Re: *SEQRA Review*
Inergy Midstream, LLC/Finger Lakes LPG Storage LLC
Liquefied Petroleum Gas Storage Facility
Town of Reading, Schuyler County

RE: *Design Objectives to Satisfy DEC Dam Safety Requirements
Brine Pond*

FINGER LAKES STORAGE BRINE POND GRADING PLAN

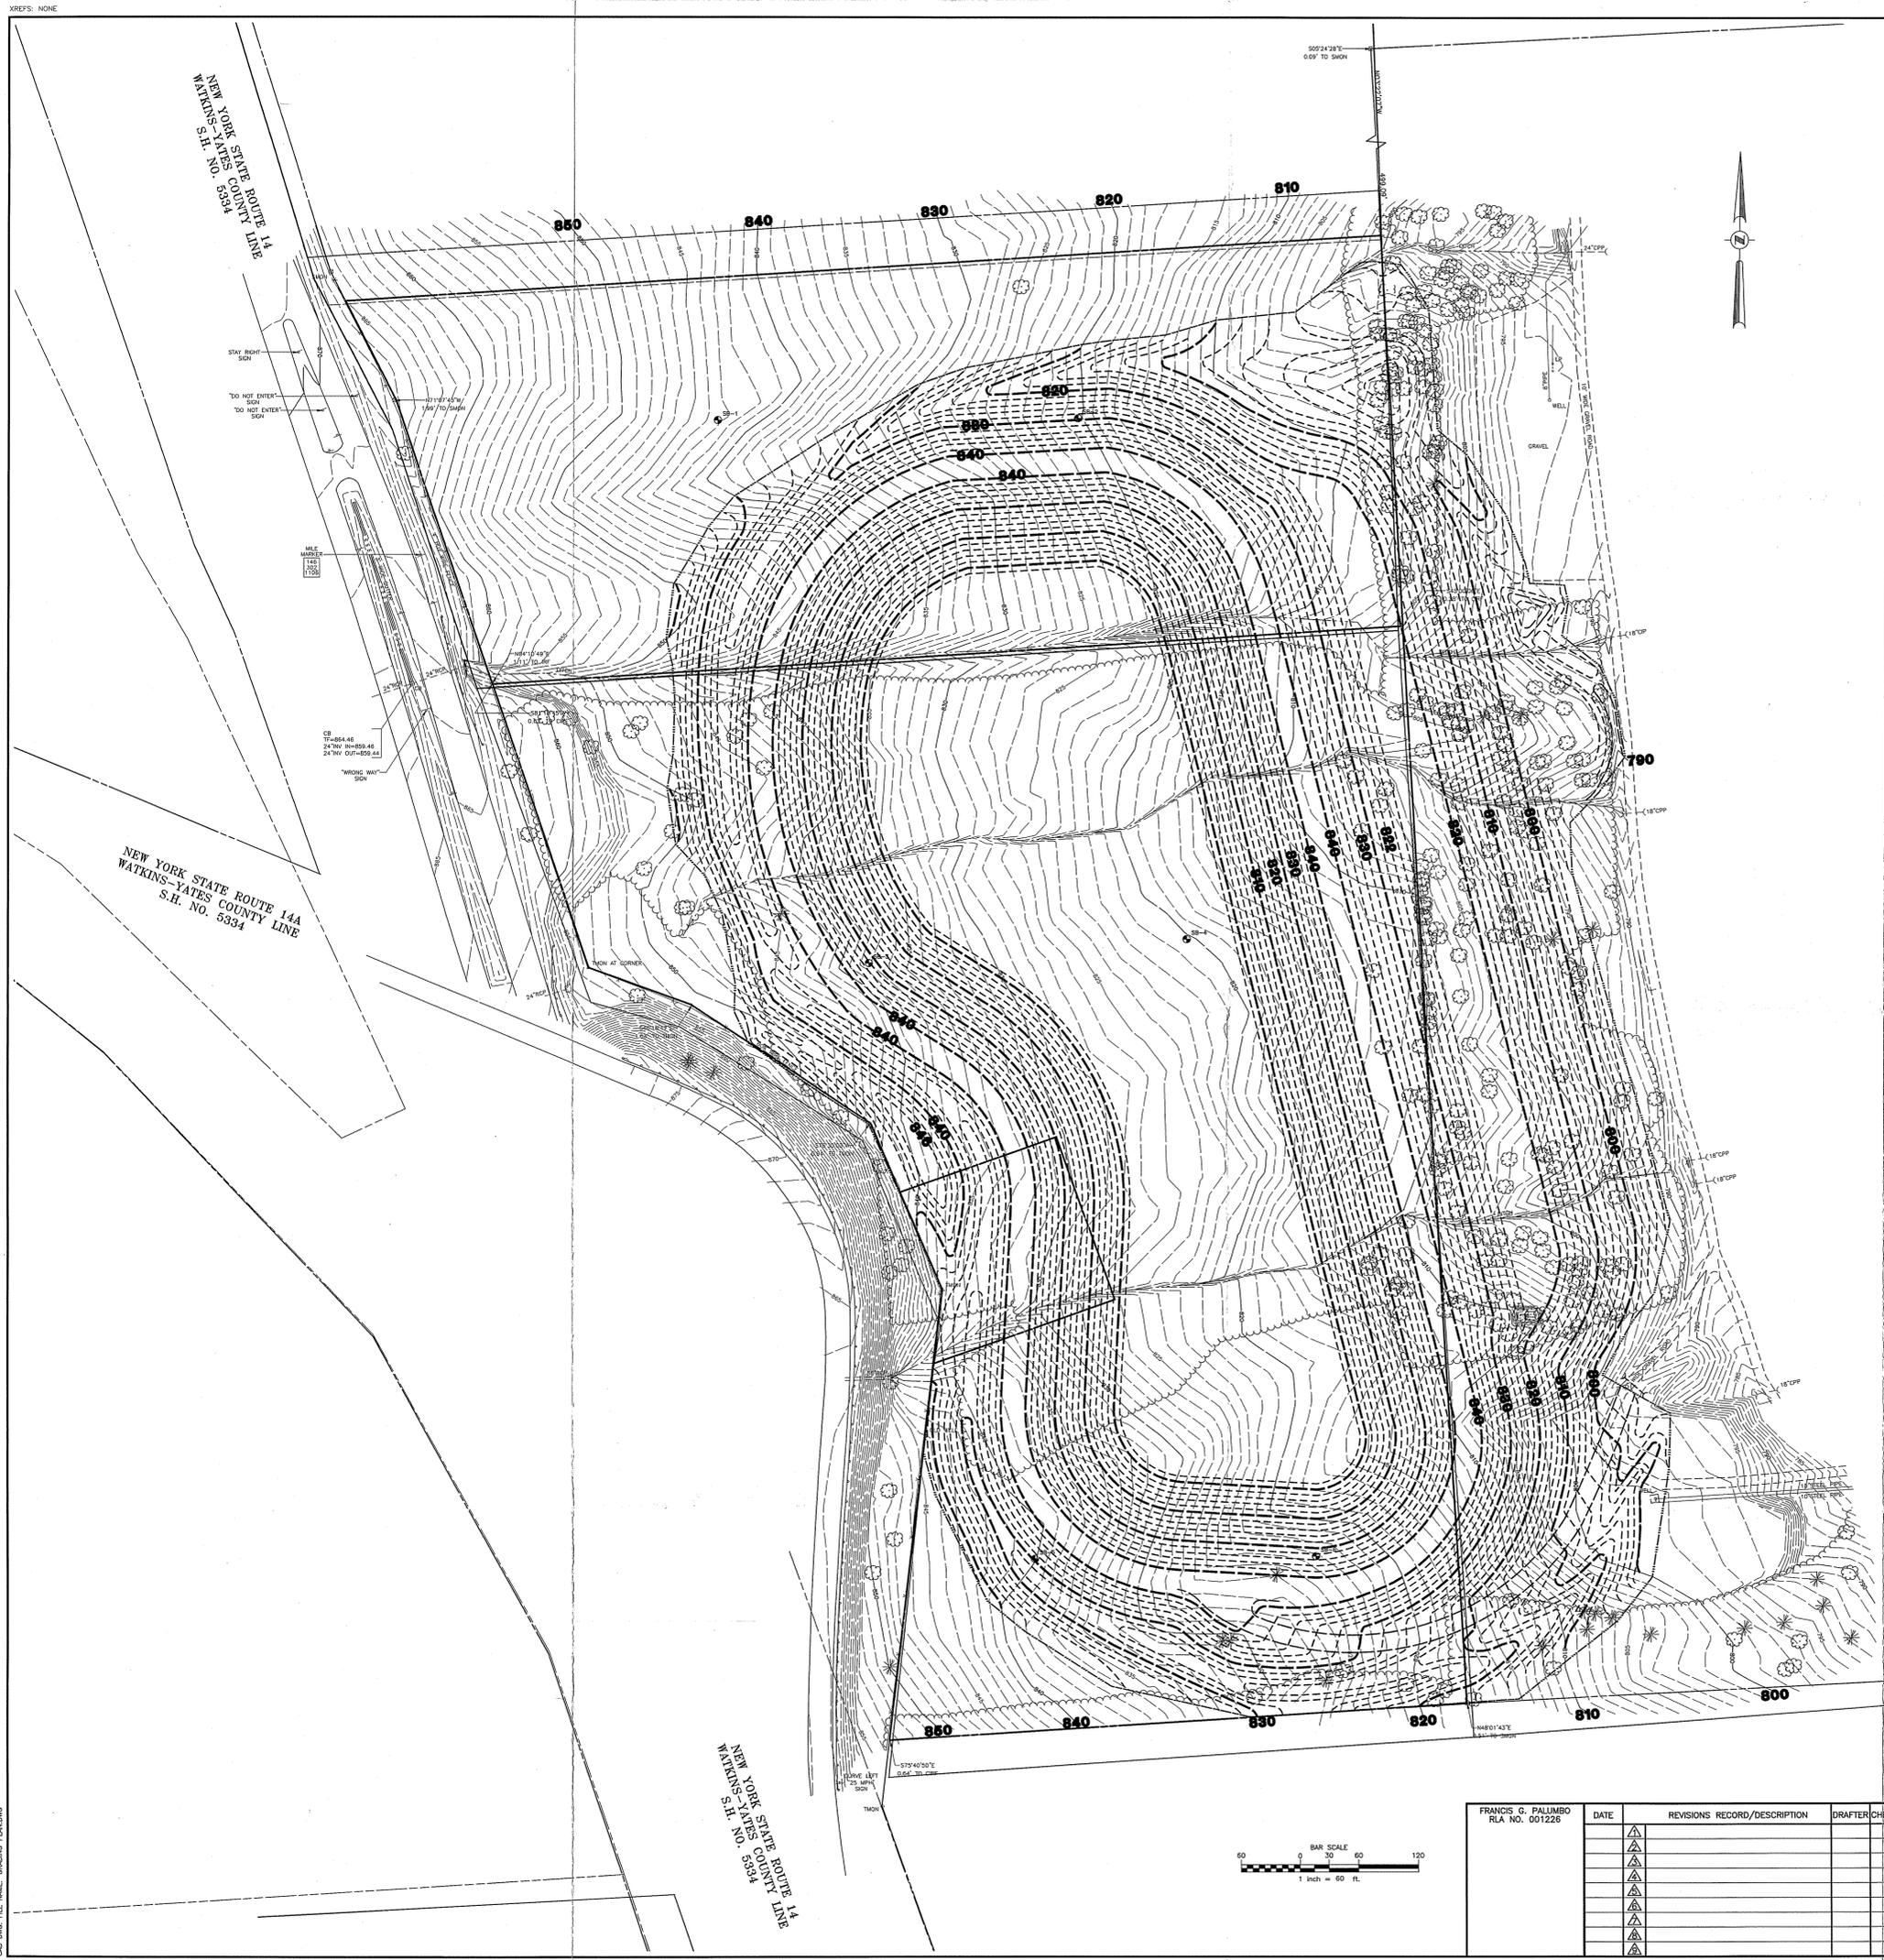
1) The October 20, 2009 Planning Board Presentation Summary, which accompanied the October 23, 2009 letter, did not adequately detail design information. For example, it is stated that 6 soil test borings were taken, but it is not clear from the submission where they were taken, how deep, what soils were encountered, etc. The Section Plan only indicates embankment fill, and soil layers 1 & 2 without any detail or characterization. It does not show the western end of the impoundment, and its relation to bedrock. It is also not clear how the depth to groundwater was addressed. Please provide additional calculations regarding stability and compaction. Finally, while an Article 15, Section 0503 Dam Safety permit is not required for this structure, it is suggested that those technical standards be met.

*A copy of the test borings and a preliminary grading plan (showing the soil boring locations) are provided herein as **Exhibit C**. Even though the brine pond is not subject to DEC dam permitting requirements, its design will meet the Department's guidelines for the Design of Dams, dated January 1985, as revised January 1989. Finger Lakes is willing to provide DEC with a final construction report, stamped by a professional engineer licensed in New York, attesting that the pond has been constructed as designed.*
